Access Compliance Report

Public Rights-of-Way

(Curb Ramps)

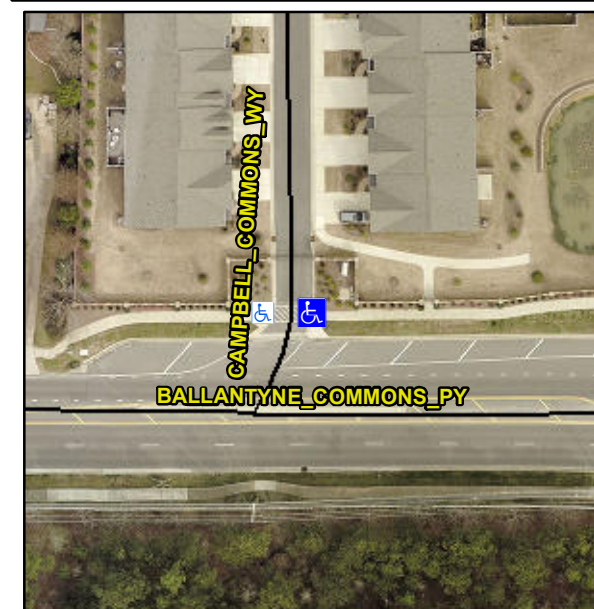
NO CURB LINE

R304.5.3

Remove & Replace Entire Ramp.
